CITY OF KELOWNA
MEMORANDUM

Date: *August 13, 2015 (revision 1- remove references to subdivision requirements)*
File No.: Z15-0038
To: Urban Planning (LK)
From: Development Engineering Manager (SM)
Subject: 980 Mayfair Road – Lot A, Plan 22053, D.L. 143, ODYD

The Development Services Branch comments and requirements regarding this application to rezone the subject property from RU1 to RU6 are as follows:

SKETCH PLAN OF PROPOSED ROAD DEDICATION
 ON LOT A, DISTRICT LOT 143, O.D.Y.D.,
 PLAN 22053 (980 MAYFAIR ROAD)

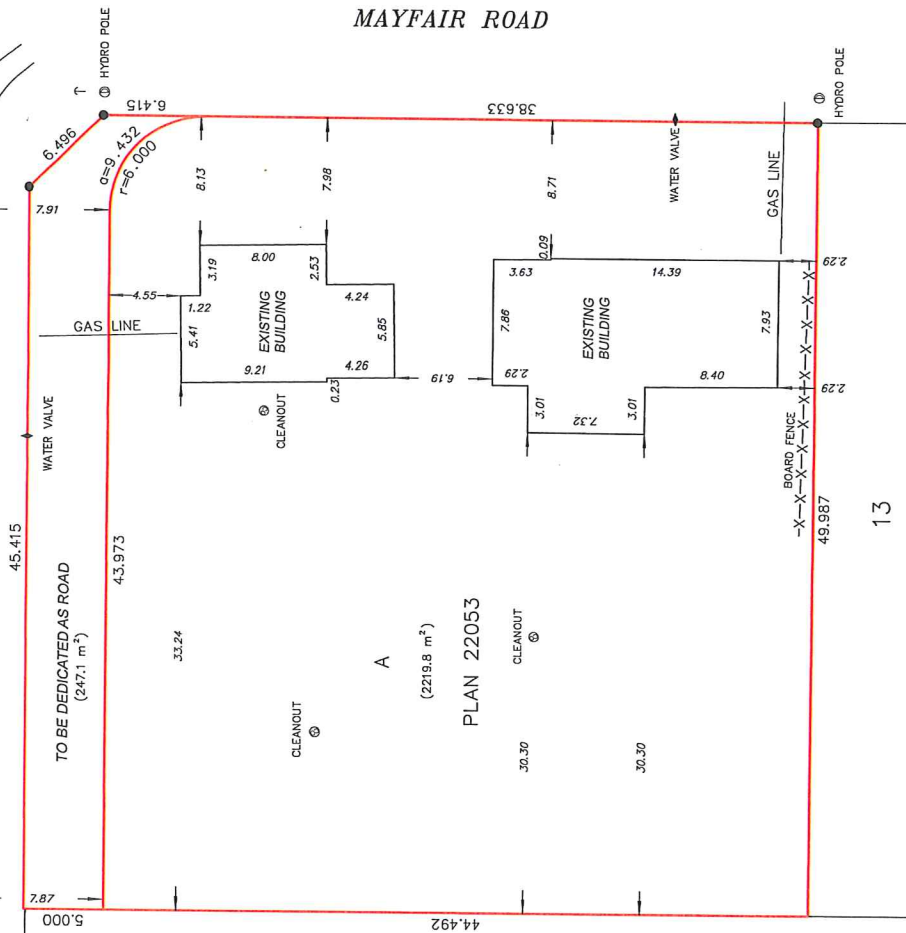
- a) Dedicate Approximately 5.0 m. along the frontage of McCurdy Road for the ultimate 30.00m. Road right of Way.
- b) Provide a 6.0 m. corner radius at the intersection of McCurdy Road and Mayfair Road.
